STAFF REPORT
COMMUNITY DEVELOPMENT DEPARTMENT

HEARING DATE: ~~9/17/2020~~ 10/22/2020
 TO: Planning & Zoning Commission
 FROM: Joe Dodson, Associate Planner
 208-884-5533
 SUBJECT: H-2020-0060
 Horse Meadows Subdivision
 LOCATION: The site is located at 710 N. Black Cat, in the NW ¼ of the NW ¼ of Section 10, Township 3N., Range 1W.

Rezone of 5.33 acres of land from the R-4 zoning district to the R-8 zoning district and preliminary plat consisting of 26 single-family residential lots and 4 common lots on 4.71 acres, by Riley Planning Services.

B. Preliminary Plat (date: 9/1/2020 9/16/2020)

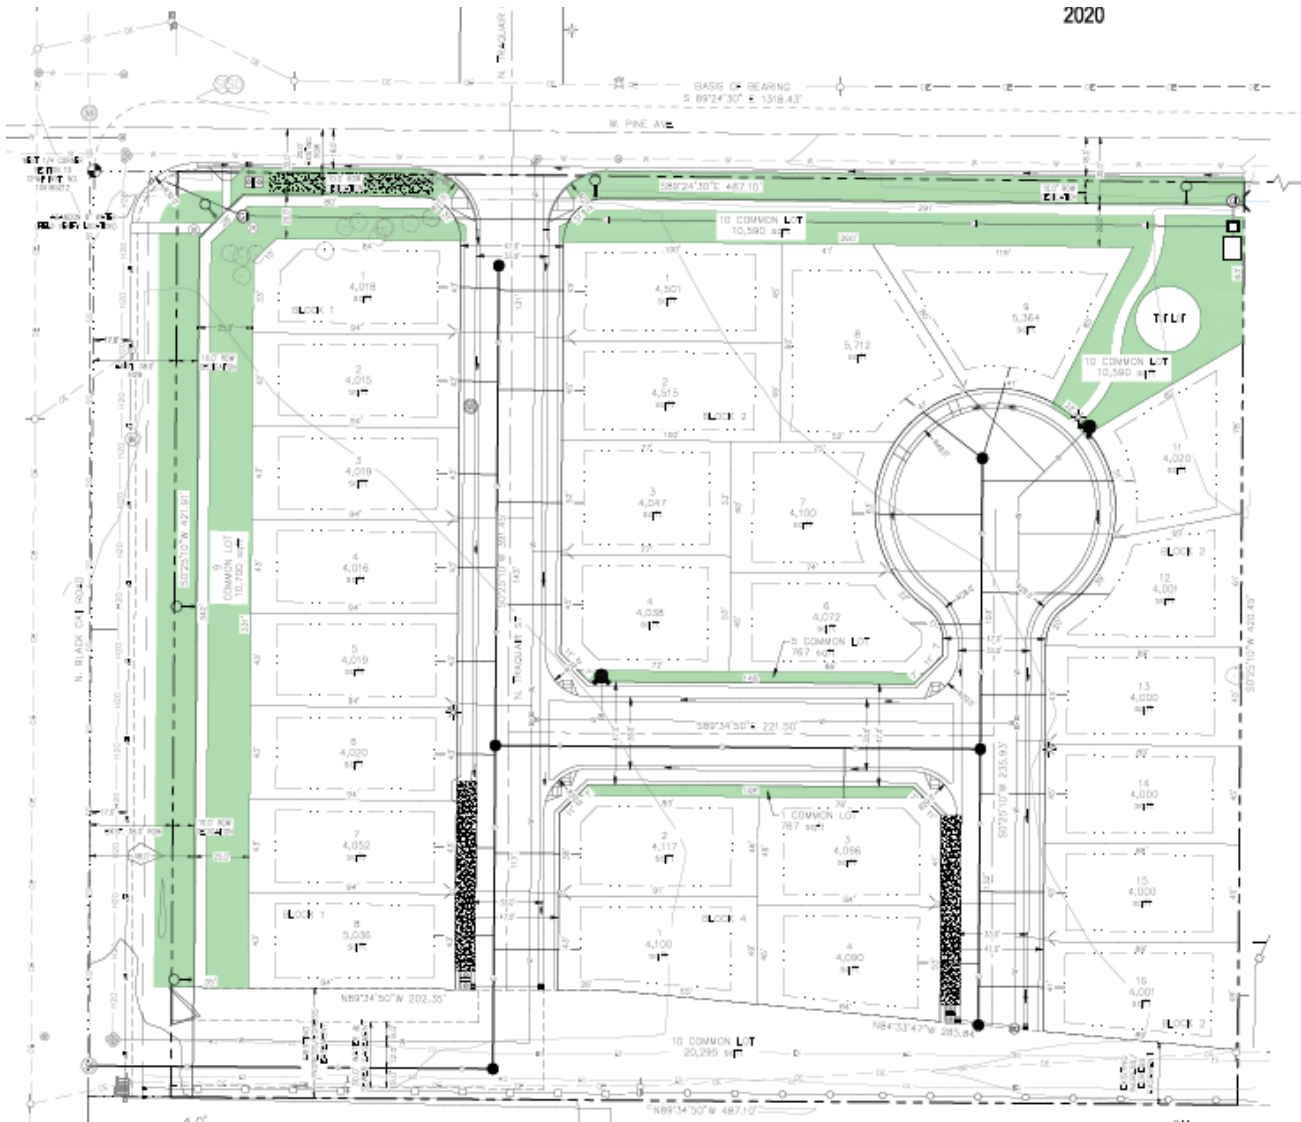
2. At least ten (10) days prior to the City Council hearing, the preliminary plat included in Section VII.B, dated 09/01/2020, shall be revised as follows:

- a. ~~Add a note prohibiting direct lot access via N. Black Cat Road.~~
 - b. Revise the plat to show the detached sidewalks along N. Black Cat Road and W. Pine Avenue with at least 4 feet of separation between it and the ultimate ACHD right-of-way.

- c. ~~Add a~~ Revise plat note number 18 regarding stating that Lot ~~9~~10, Block 1 to state: Lot 10, Block 1 is a non-buildable lot and is to be owned and maintained by the HOA until such time that it redevelops as either common open space or as public right-of-way only.

- d. Show Lot 6, Block 2 as a common open space lot instead of a building lot.
 3. At least ten (10) days prior to the City Council hearing, the landscape plan included in Section VII.C, dated 04/20/2020 shall be revised as follows:

C. Landscape Plan (date: 4/20/2020) (NOT APPROVED)

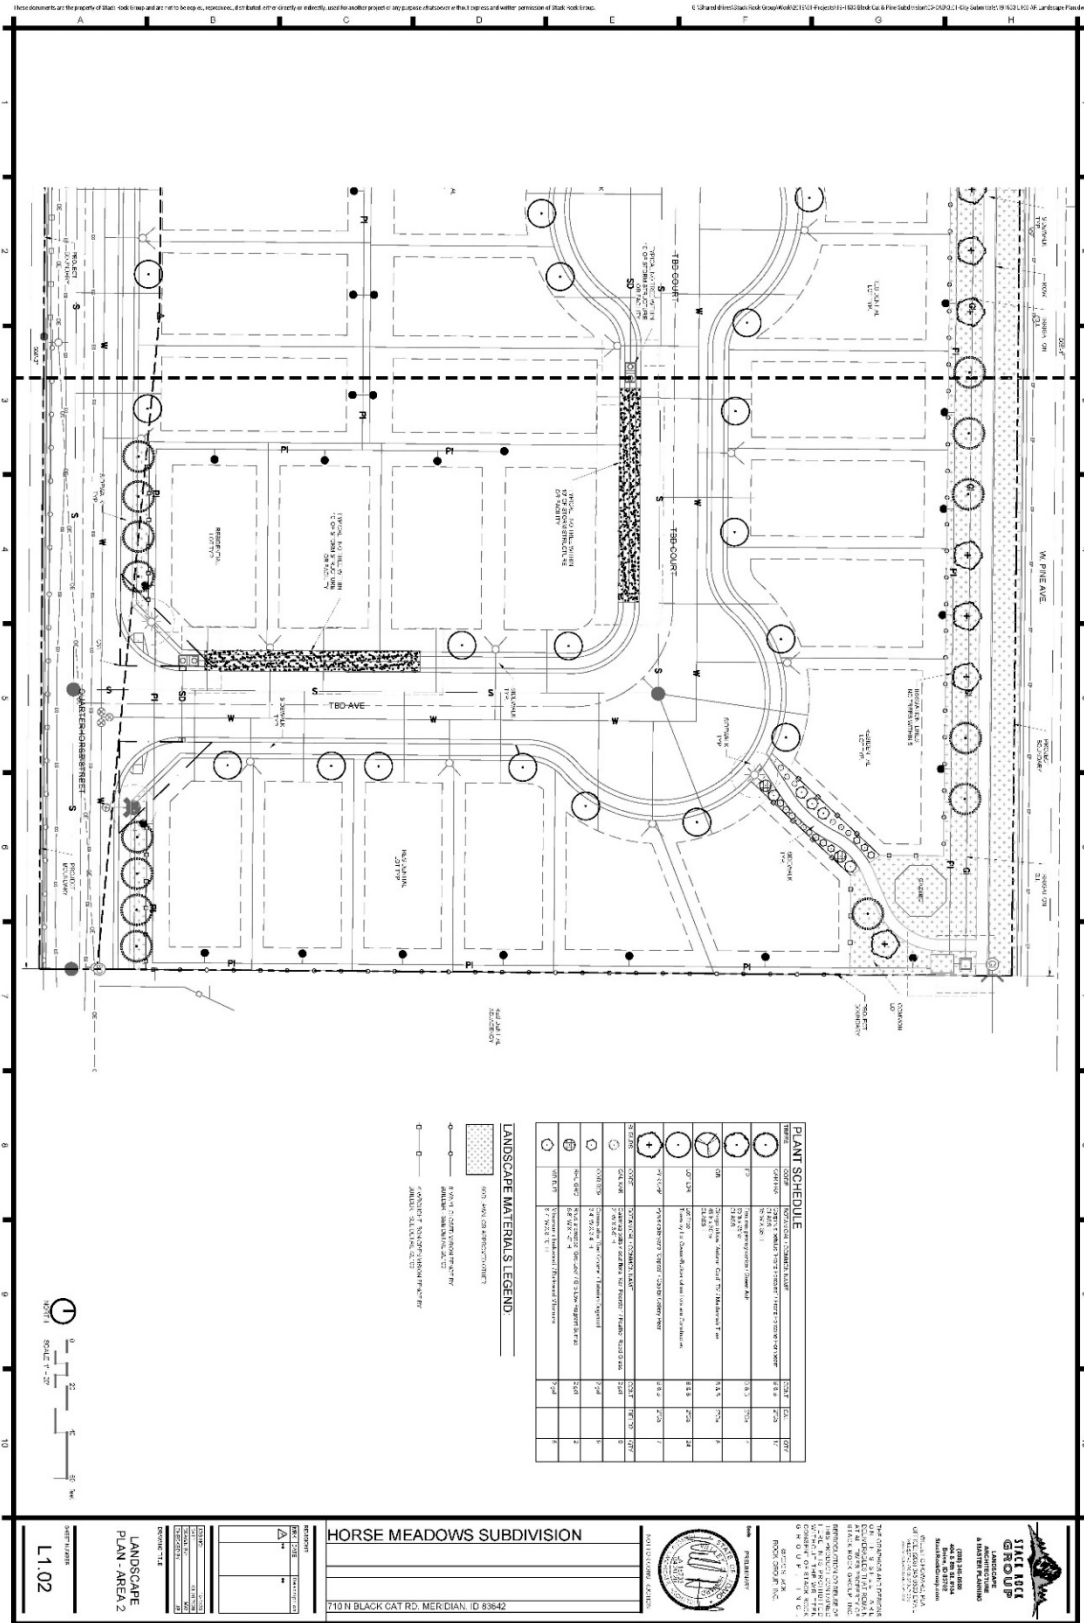
- a. Revise the landscape plan to show the required shrubs and other vegetative ground cover within the street landscape buffers along N. Black Cat Road and W. Pine Avenue.

- b. Revise the landscape plan to show the layout of the revised preliminary plat; make any adjustments to the calculations table if needed.

- c. Revise the landscape plans to show the detached sidewalks along N. Black Cat Road and W. Pine Avenue with at least 4 feet of separation between it and the ultimate ACHD right-of-way.

- d. Show Lot 6, Block 2 as a common open space lot instead of a building lot with the correct vegetation as set forth in UDC 11-3G and 11-3B.
 - e. Revise the landscape plans to show Lot 10, Block 1 with vegetative ground cover.

- f. Add a detail of the proposed tot-lot to the landscape plans to ensure quality of structures.
4. Prior to the Commission hearing, the Applicant shall provide the following to Planning Staff: ~~1) building elevations depicting those homes that are alley loaded and side loaded, and; 2) exhibits showing setback compliance with the proposed building lot sizes and different style homes.~~

E. Proposed use of existing access easement

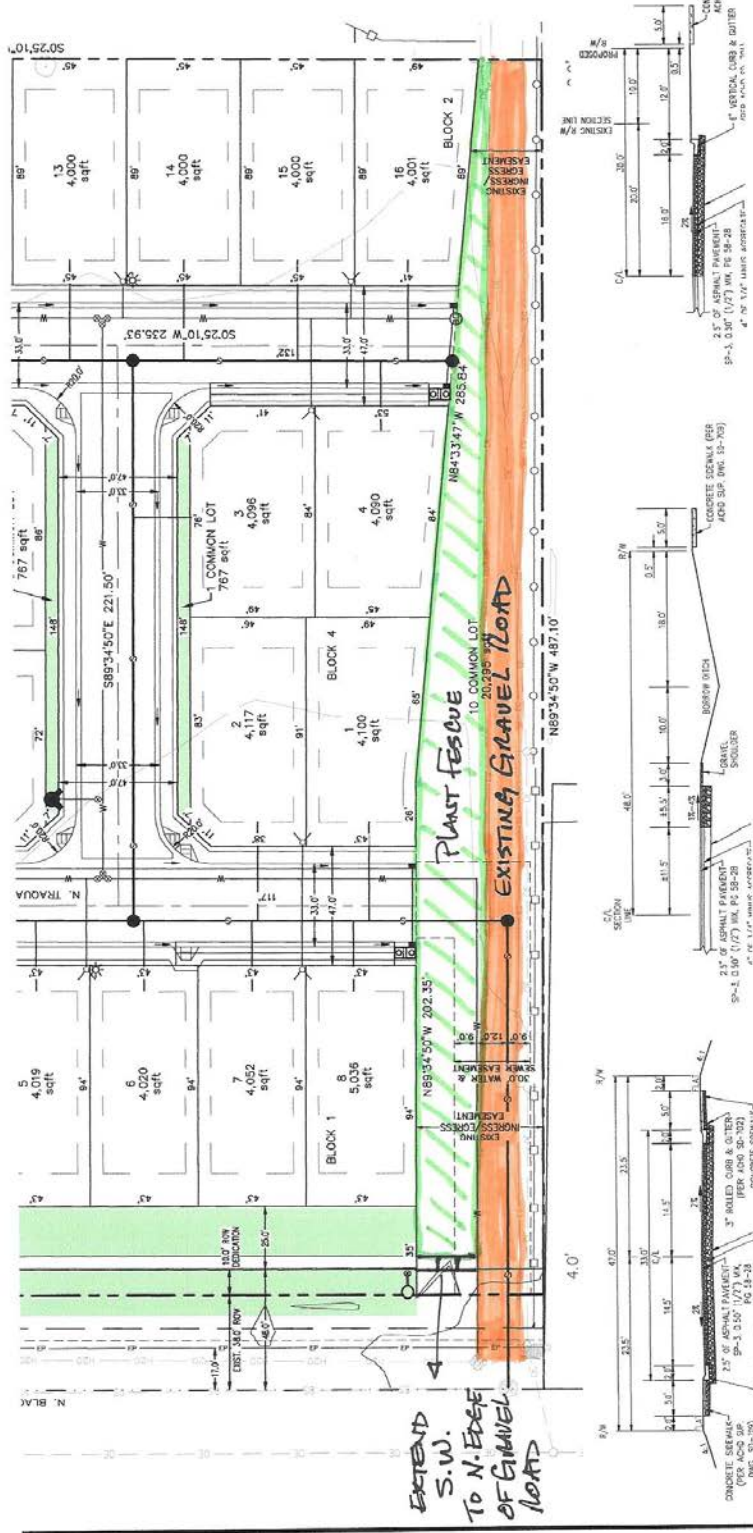
The new layout proposes access off of Pine Avenue in line with N. Traquair Place on the north side of Pine. The internal streets provide two north-south stub streets to the existing private lane (Quarterhorse Lane) that will be extended in the future and a cul-de-sac that serves six (6) homes connects back to the westerly north-south street via an alleyway. ~~This alleyway is where the Applicant is proposing the alley loaded and side loaded homes~~. Staff can support this revised layout more than previously submitted plats as it places the easement within a lot of its own, shown as Lot 910, Block 1. ~~However, this lot is not specifically addressed on the plat or within the revised narrative. Therefore, the Applicant has not shown sufficient evidence how this layout and the existing easement could work in the future with future development to the east, specifically with the future road network. Will it be green space? Will it become part of the future road network? These are questions the Commission and Council should ask of the Applicant.~~ Staff understands that there may be no precise way to know what will happen ~~here~~ with this easement but it is often up to the developer/Applicant to show Staff that all aspects of a property have been vetted; Staff is ~~not now~~ comfortable in stating that this due diligence has occurred with the future of this access easement because the Applicant has provided an exhibit showing this lot as common open space to be landscaped with grass and still accommodate the existing gravel access road for the servient sites. In addition, the area of the access easement that is between the new local north-south street and Black Cat will hold both a sewer and water main line in order to loop the systems. These utilities require a 30-foot wide easement which will overlay the lot and

make this area non buildable in perpetuity. The Applicant has stated to Staff that the remaining easement area is best suited for future right-of-way for future redevelopment to the southeast and Staff agrees. The exhibit provided by the Applicant does not specifically show this because it is unknown where future access to the south could be taken from but the story has been told in both discussion and in the response to the previous staff report.

Despite the unknowns, Staff is more comfortable supporting this revised plat with the requirement of an additional DA provision to ensure this easement area is used appropriately in the future. This recommended provision is to restrict Lot 910, Block 1 as a non-buildable lot for either common open space or future right-of-way dedication as other easement holders redevelop their own properties and relinquish their rights to this private lane access in the future.

- e. Lot ~~9~~10, Block 1 (the lot containing W. Quarterhorse Lane) shall be a non-buildable lot owned and maintained by the HOA until such time that it is redeveloped in the future as either common open space or as public right-of-way. ~~Prior to the Commission hearing, the applicant shall provide an exhibit that demonstrates the extension of the 25-foot wide landscape buffer, the two stub streets and integration with the adjacent properties to ensure this area is utilized.~~
